INDIAN POINT UNIT 2  
CONTAINMENT INSERVICE INSPECTION  
FIRST PERIOD EXAMINATIONS

Category E-A, Liner General Visual Examination  
Tab E - Inspector Certification Records

GENERAL VISUAL EXAMINATION OF CONTAINMENT LINER  
FOR ASME SUBSECTION IWE

**LINER INSPECTION ZONE IWE-095-002**  
(INTERIOR DEVELOPED VIEW, LOOKING INSIDE OUT)

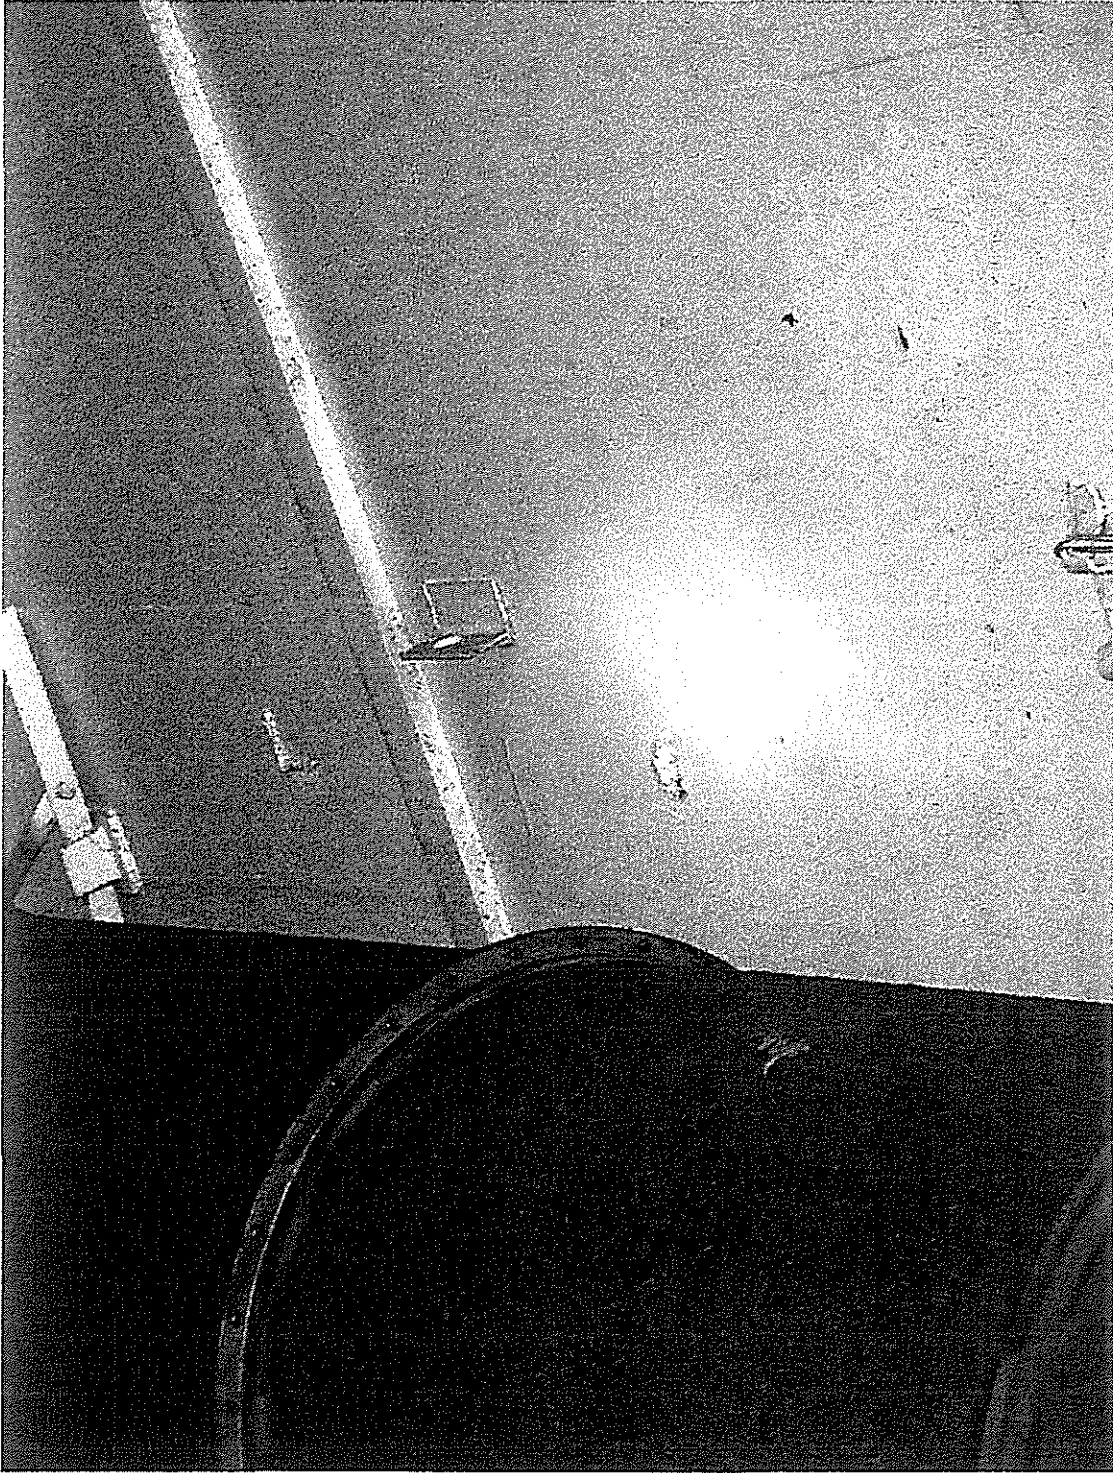
Item No.	Discussion	Acceptable	Additional Eval. Req'd.
01 - 04 06 - 11	The reported conditions reflect deterioration of the coating, primarily delamination/loss of bond between the primer and topcoat. Since the primer is intact there is no reason to suspect any degradation of the liner. Minor surface corrosion is noted in a couple of locations, but does not reflect any significant material loss and is not an aggressive condition. These conditions are not significant relative to Containment structural integrity. Examination at the next regular inspection period is sufficient to monitor them.	✓	
05	The welds appear to be remnants from previous attachments, most likely scaffolding brackets used during construction. The weld surface is irregular and thus the coating will not bond well. The corrosion is minor and does not reflect any significant loss of liner material. Examination at the next regular inspection period is sufficient to monitor this condition.	✓

**LINER INSPECTION ZONE IWE-095-004**  
 (INTERIOR DEVELOPED VIEW, LOOKING INSIDE OUT)

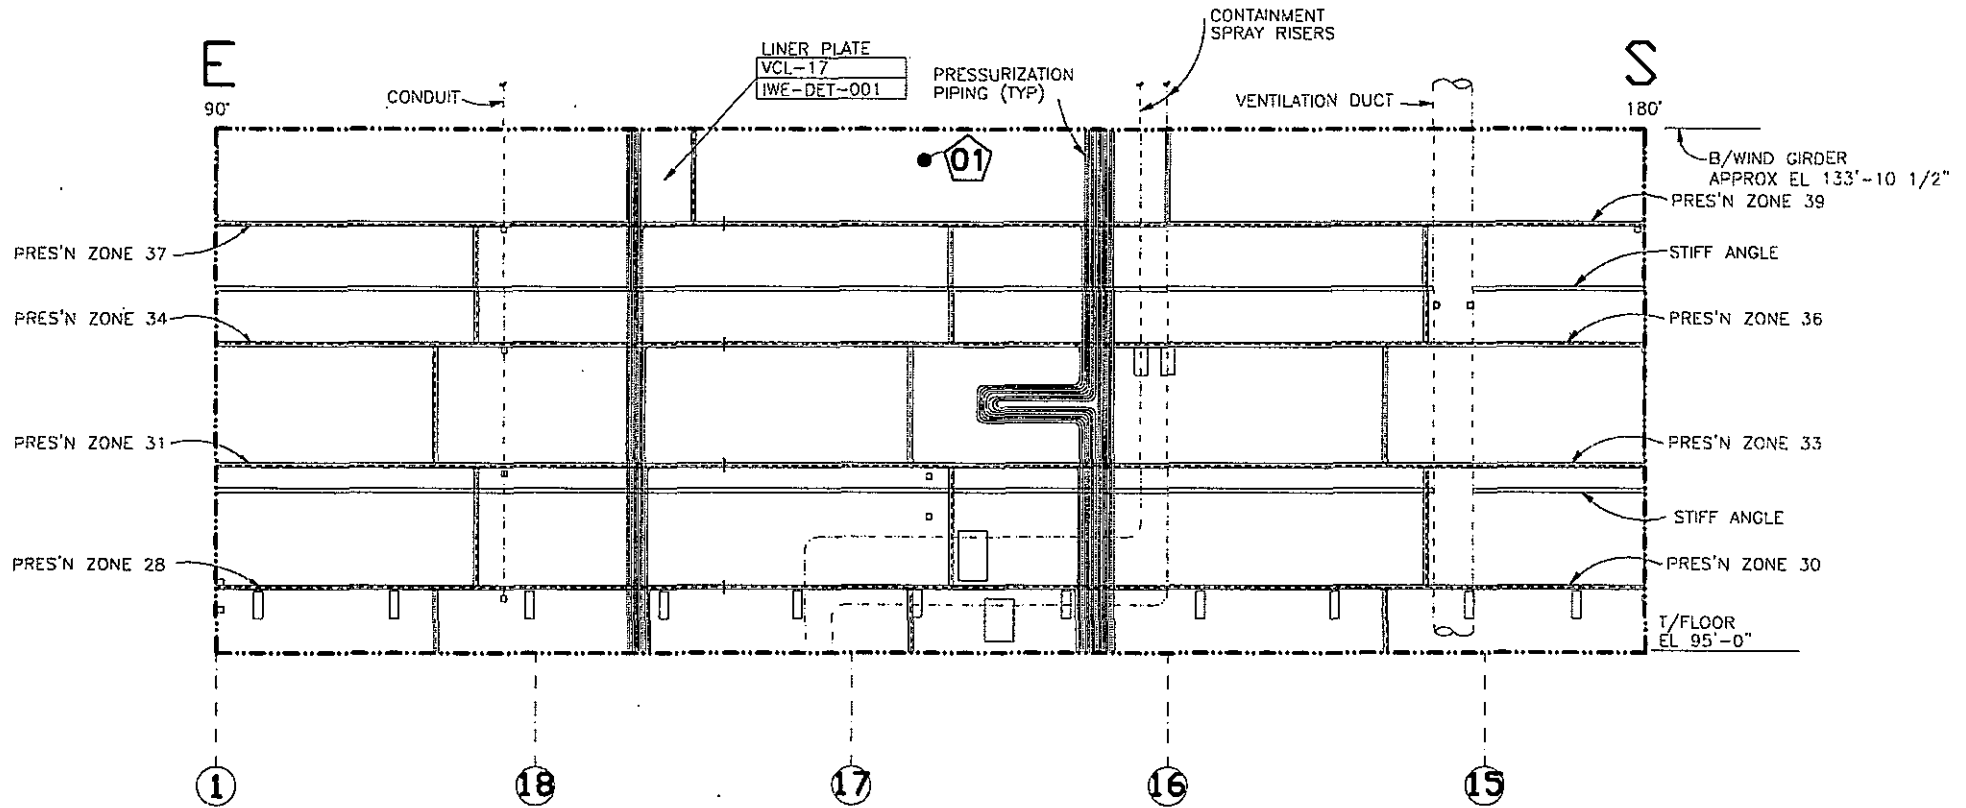
Item No.	Description	Photo
01	Coated 3" circumferential attachment shows minor rusting at the lower area. Rusting is classified ASTM D610, Grade 5, (3% of surface rusted). Primer intact.	None

Item No.	Discussion	Acceptable	Additional Eval. Req'd.
01	Rusting of the attachment has not degraded the liner. The primer was observed to be intact and thus the liner is protected. Examination at the next regular inspection period is sufficient to monitor this condition.	✓

**LINER INSPECTION ZONE IWE-134-001**  
 (INTERIOR DEVELOPED VIEW, LOOKING INSIDE OUT)

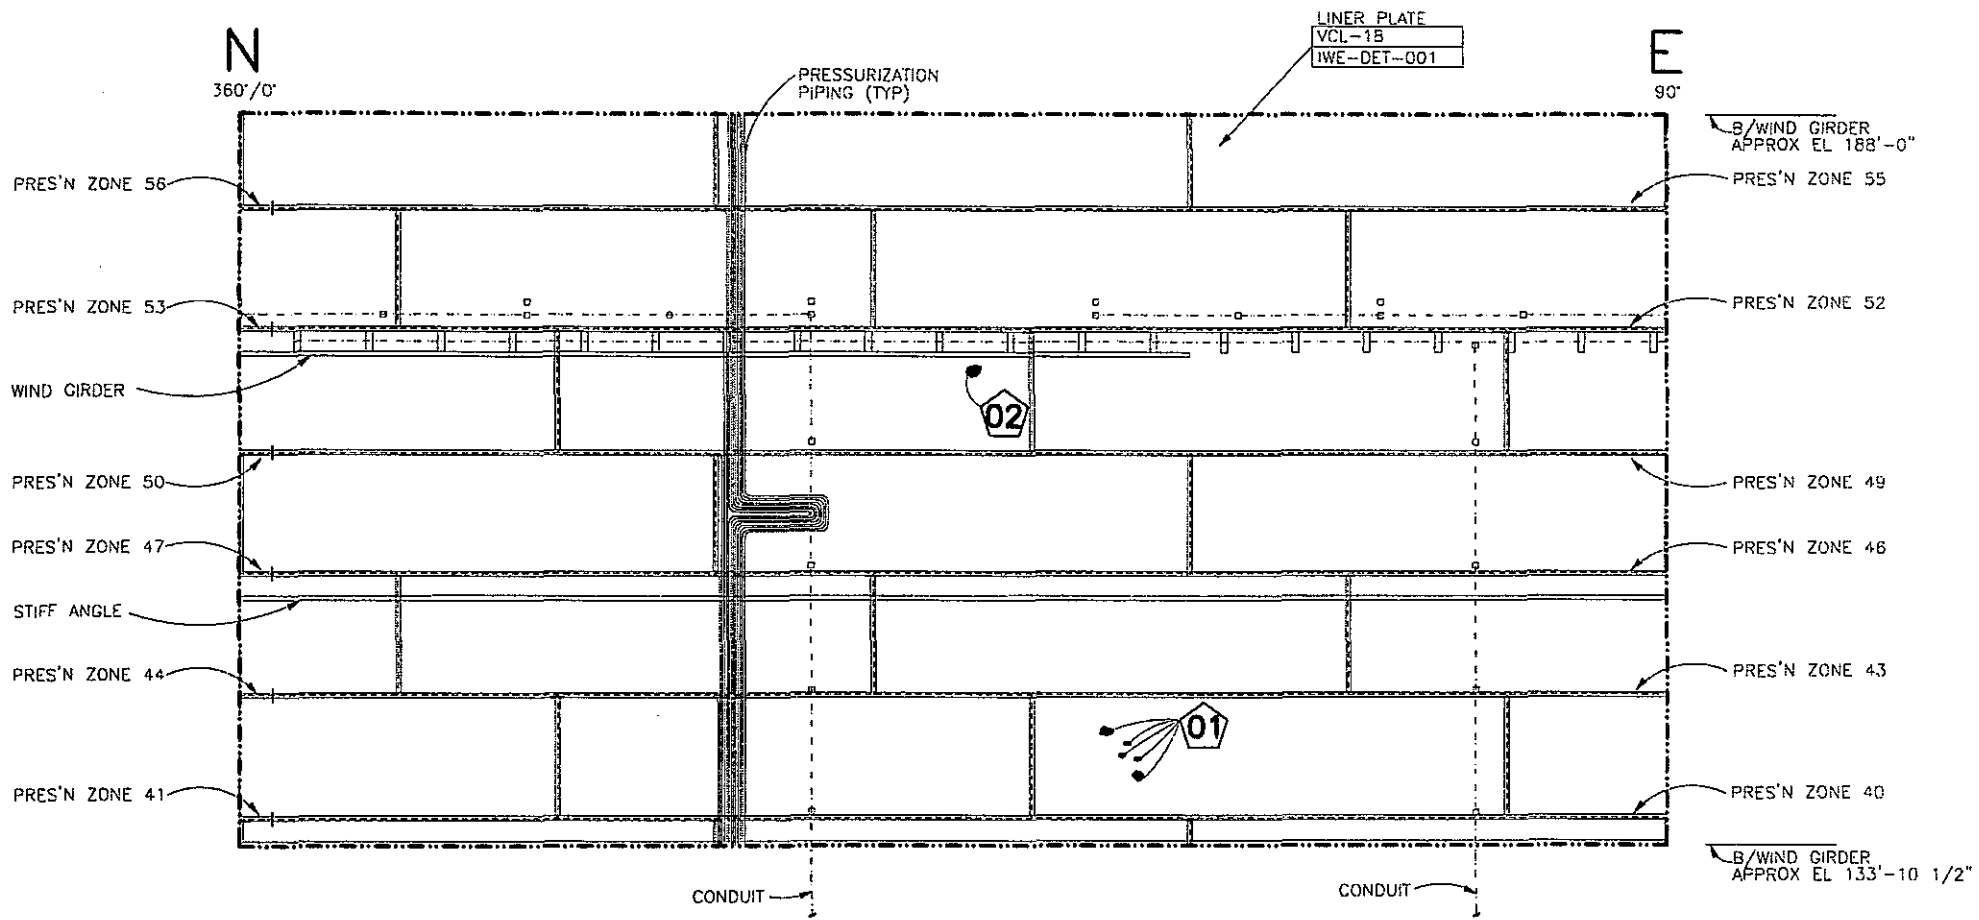
Item No.	Description	Photo
01	Five small areas approximately 1"x1" each showing delamination and peeling.in topcoat. Primer intact.	None
02	One (1) area approximately 3"x6" show delamination and peeling in topcoat. Primer intact.	None

Item No.	Discussion	Acceptable	Additional Eval. Req'd.
01, 02	The reported conditions reflect deterioration of the coating (loss of bond between the primer and topcoat). Since the primer is intact there is no reason to suspect any degradation of the liner. This condition is not significant relative to Containment structural integrity. Examination at the next regular inspection period is sufficient to monitor these conditions.	✓

**LINER INSPECTION ZONE IWE-134-002**  
 (INTERIOR DEVELOPED VIEW, LOOKING INSIDE OUT)

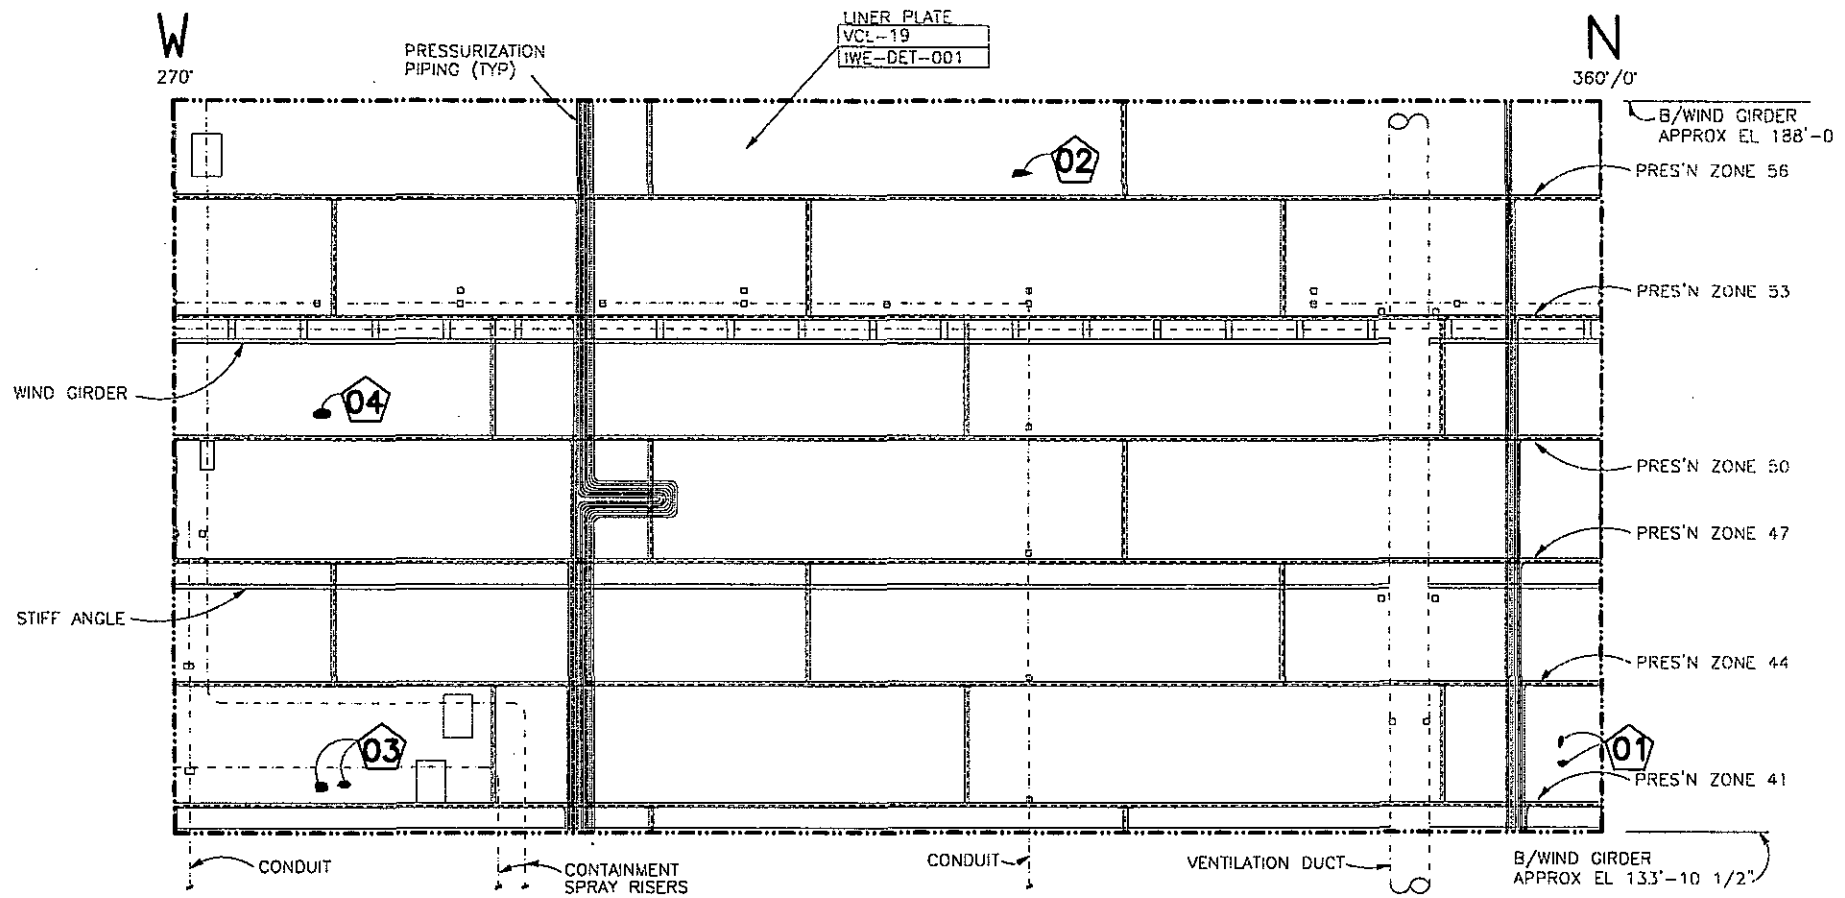
Item No.	Description	Photo
01	Two (2) 1"x 4" areas shows top coat delamination and peeling in previously repaired area. Primer intact.	None
02	One (1) area shows top coat delamination checking with minor rusting in center. Rusting is classified ASTM D610, Grade 1, (3% of surface rusted). Checking to ASTM D660, Mosaic, Grade 8. Primer intact.	None
03	Two (2) areas 6"x12" and 12"x18" shows top coat delamination, checking and peeling. Primer intact. Checking to ASTM D660, Mosaic, Grade 8.	None
04	One (1) 4"x 4" area shows top coat delamination and checking. Primer intact. Checking to ASTM D660, Mosaic, Grade 8.	None

Item No.	Discussion	Acceptable	Additional Eval. Req'd.
01, 03, 04	The reported conditions reflect deterioration of the coating (loss of bond between the primer and topcoat). Since the primer is intact there is no reason to suspect any degradation of the liner. This condition is not significant relative to Containment structural integrity. Examination at the next regular inspection period is sufficient to monitor these conditions.	✓	
02	The reported condition reflects deterioration of the coating (delamination/loss of bond between the primer and topcoat). Minor surface corrosion is noted, but does not reflect any significant material loss and is not an aggressive condition. This condition is not significant relative to Containment structural integrity. Examination at the next regular inspection period is sufficient to monitor this condition.	✓

**LINER INSPECTION ZONE IWE-134-003**  
 (INTERIOR DEVELOPED VIEW, LOOKING INSIDE OUT)

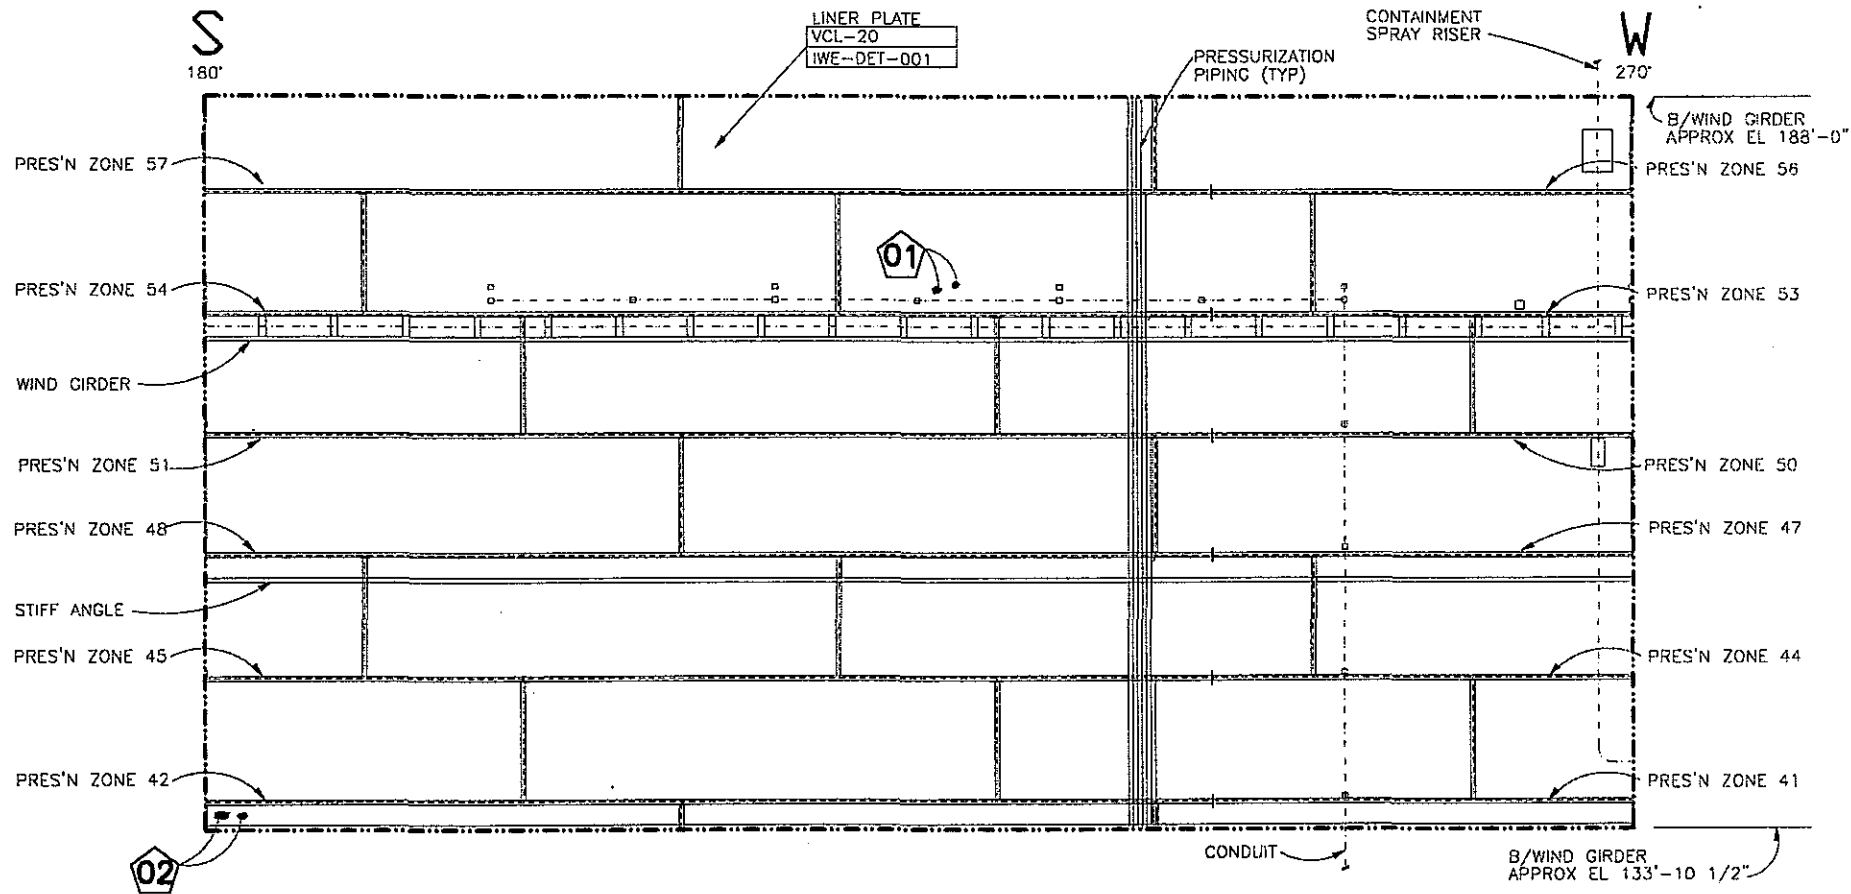
Item No.	Description	Photo
01	Two (2) 2"x 3" areas show top coat delamination and checking. Primer intact. Checking to ASTM D660, Mosaic, Grade 8.	None
02	One (1) 1"x 1" area show top coat delamination checking with rusting and signs of primer coating diminishing. Rusting is classified as ASTM D610, Grade 4, 10% of surface rusted. Checking to ASTM D660, Mosaic, Grade 8. Primer intact.	None

Item No.	Discussion	Acceptable	Additional Eval. Req'd.
01	The reported condition reflects deterioration of the coating (loss of bond between the primer and topcoat). Since the primer is intact there is no reason to suspect any degradation of the liner. This condition is not significant relative to Containment structural integrity. Examination at the next regular inspection period is sufficient to monitor these conditions.	✓	
02	The reported condition reflects deterioration of the coating (delamination/loss of bond between the primer and topcoat). Minor surface corrosion is noted, but does not reflect any significant material loss and is not an aggressive condition. This condition is not significant relative to Containment structural integrity. Examination at the next regular inspection period is sufficient to monitor this condition.	✓
